## **SAFETY RECALL CAMPAIGN 2A89**

### UH200A CVT Driven Face Replacement

- Affected Models:** 2018 - 2019 UH200A (Burgman 200)
- Affected Departments:** Management, Service, Sales, Warranty, Parts, Accessories
- Revision:** **New countermeasure part identification information** (page 3)

**Identification of original production & updated countermeasure parts**

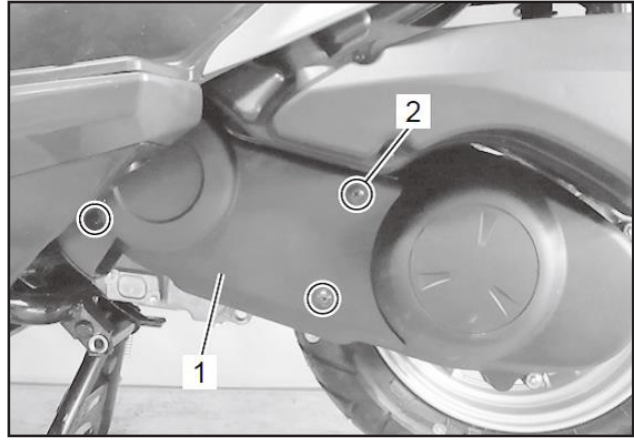
Effective with October 20, 2021 bulletin, use the date of manufacture to identify the updated countermeasure part for this recall service.

**Original production driven face set**  
① Date of manufacture before **JAN.10.2019**

**Updated countermeasure driven face set**  
② Date of manufacture after **JAN.11.2019**
